STAFF REPORT

File Number	PL 14-093	Contact	Jenn Reed Moses, jmoses@duluthmn.gov	
Application Type	Shoreland Variance	Planning Commission Date	August 12, 2014	
Deadline for Action	Application Date	July 11, 2014	60 Days	September 9, 2014
	Date Extension Letter Mailed	July 18, 2014	120 Days	November 8, 2014
Location of Subject	4896 Arnold Road			
Applicant	Kathleen Howard	Contact	khmnadmin@gmail.com	
Agent	N/A	Contact	N/A	
Legal Description	PID 010-2720-00055			
Site Visit Date	N/A	Sign Notice Date	July 29, 2014	
Neighbor Letter Date	July 21, 2014	Number of Letters Sent	12

A variance to build a 336 sq ft addition to an existing 576 sq ft home. Addition would be 78 feet from Amity Creek, a coldwater stream, which has a 150' structure setback.

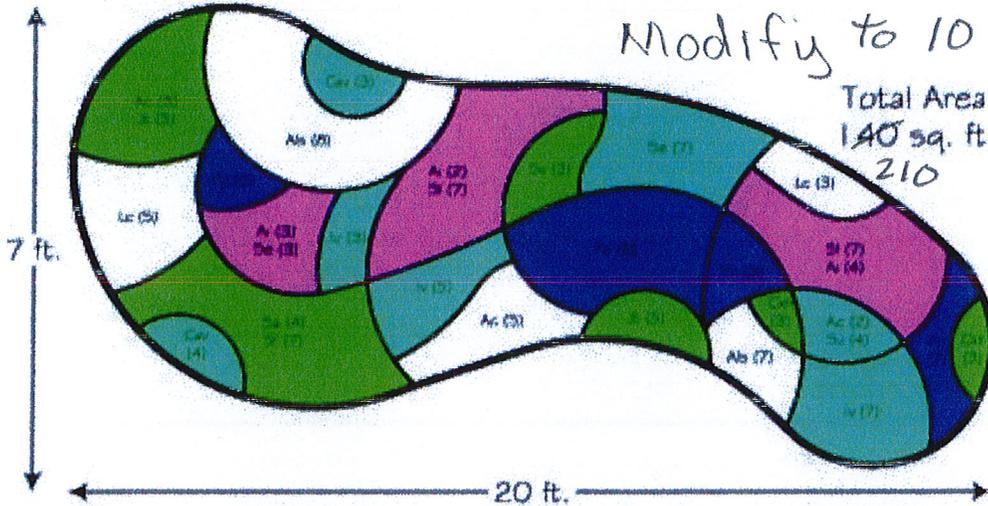
Modify to 10 x 30

Modify to
7' x 30'
210 sq ft
